SEWAGE DISPOSAL SYSTEM

DEPARTMENT OF HEALTH AND MENTAL HYGIENE

A REPAIR

ADDRESS 26108 Mullinix Mill Road, Mt. Airy. 21771 PHONE (301)253-5254

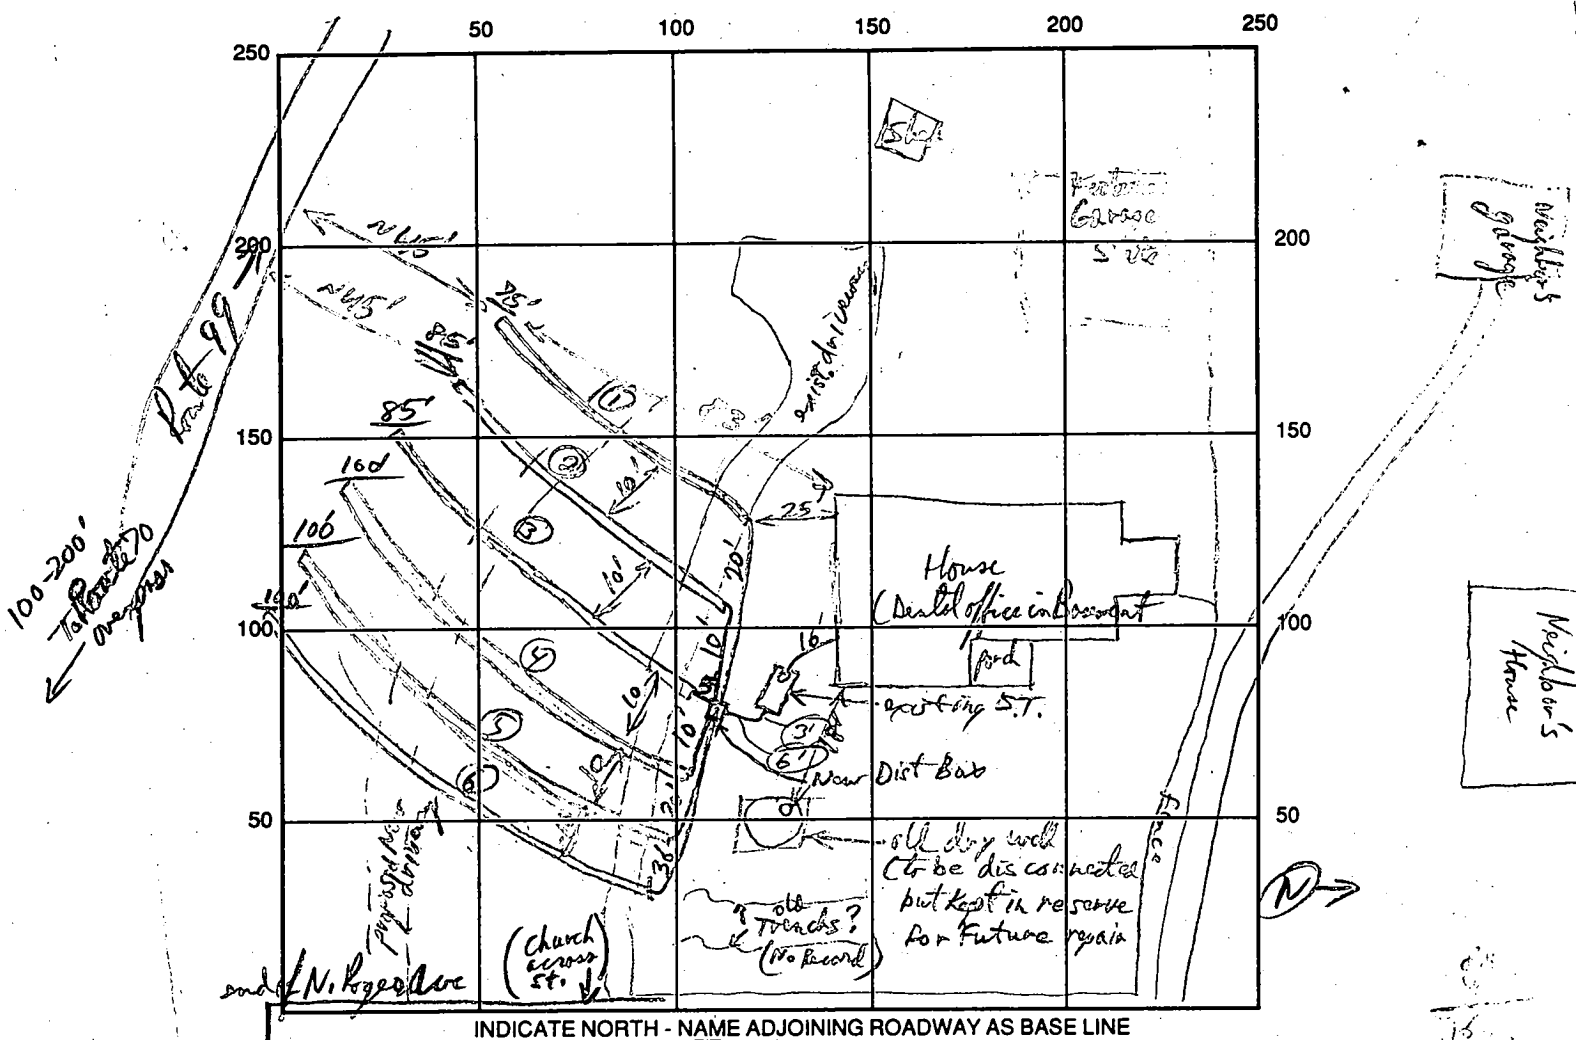
LINEAR FEET OF TRENCH REQUIRED 300 LF of shallow plus 225 lin. ft. of deep trench

300^{LF} Shallow Trench Bottom at 4-5 ft, 2 ft stone, 3 ft wide, in lot at 2 ft.

225^{LF} Deep Trench at 8 ft Bottom, 4 ft stone, 2 ft wide, in lot at 3 or 4 ft as needed to get

gravity flow. Based on middle open trench inspection deep trench design may be approvable by

sanitarian for more than the 225 LF proposal, with a corresponding reduction in shallow trench length

REMARKS: Existing Dry well full - water level is 12" above dry lid - also seen wet spots ^{surface} on ground about 20-25 ft from D.W. Cleanout. Probed of clean. Noted CL to 4ft in To 3 under old driveway. Trenches 4, 5 & 6 will have to be shallow trench design. Trenches 1 & 2 OK to cover, Trench #3 OK to spread fill spread fill (Gravel depth is about 18" cover over drain pipe where future driveway is to go, using probed 2500 lb gravel PVC) OK to gravel fill last trench, OK to cover system when last trench complete. RVP 5/10/96

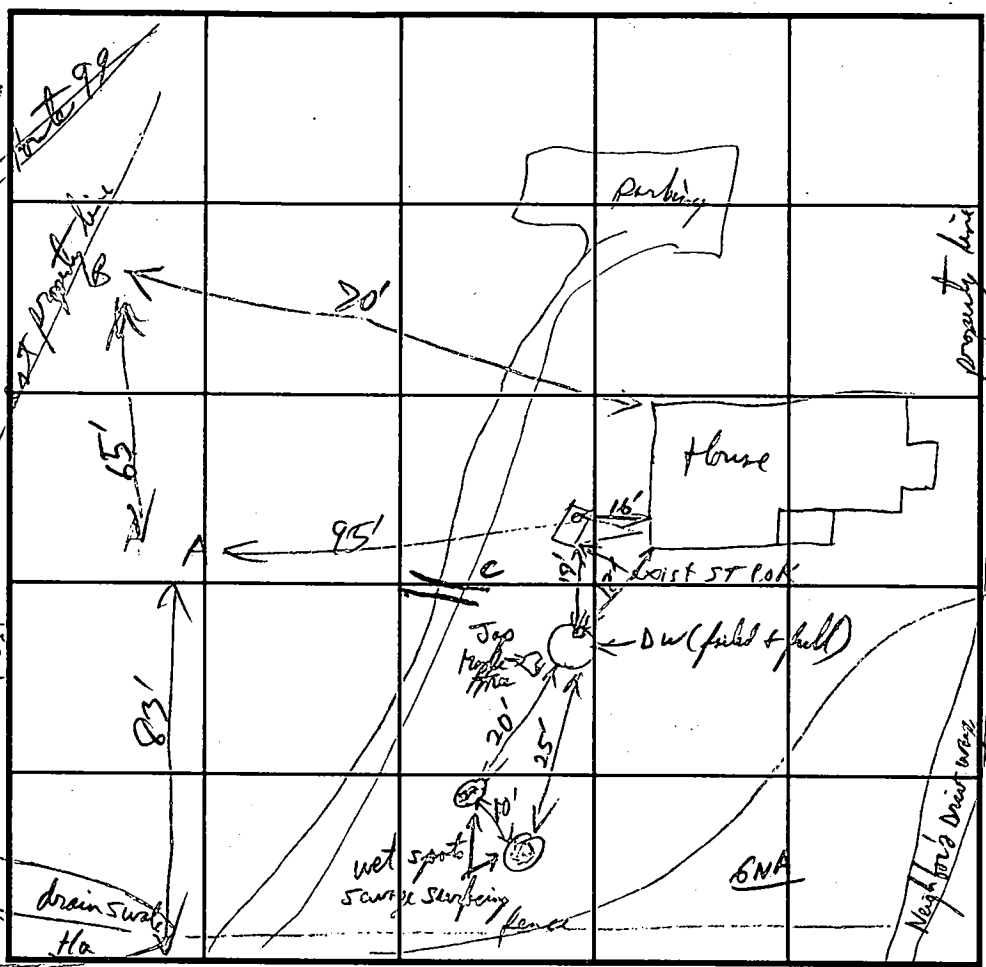
DATE	TEST NO.	DEPTH	PRE-WET		TEST - 1" DROP		TIME
			START	STOP	START	STOP	
5/9/96	A	19'	Wet Test OK soils below 2 1/2 - 3 ft, mica loam below 4 ft				
	B	14'	begin for water table OK loams between 3 and 5 ft (HSL loam at 3-5)				300 225 525
	C	(Fyio)	(water level) at 13 1/2'				
			section of Trench #3 under original driveway, as noted				
			Failed Drywell had a gray SiCL horizon with mottled boundaries typical of Glenville Soils.

REMARKS Limited depth at different elevations to water tables - split system design
TYPE OF SOIL Ch B₂, 6L B₂, (G₁ A, H₁) cherty, blends on high side, Glenville Harbor and outside
TESTED BY R. Kelly ALSO PRESENT owner, City & State Contractors
TRENCH DESIGN DATA: AVERAGE PERCOLATION TIME at 5-10 min in 600 mm - SL TRENCH WIDTH
INLET DEPTH MAXIMUM BOTTOM DEPTH SQ. FT./BEDROOM
split trench design - all Septic 3 legs in basement

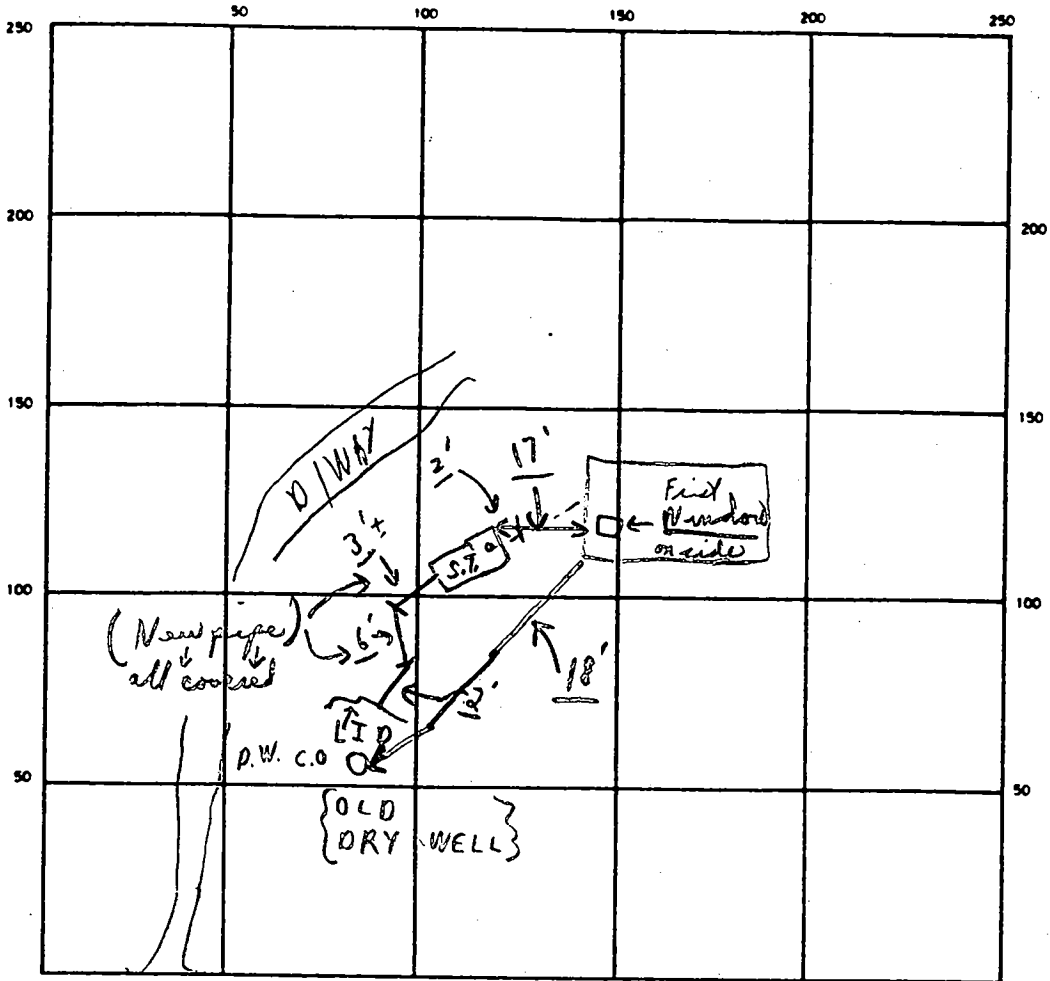
REMARKS 4/3/90 OK TO COVER ALL WORK, FINAL (1 New septic tank installed) C.B.D.
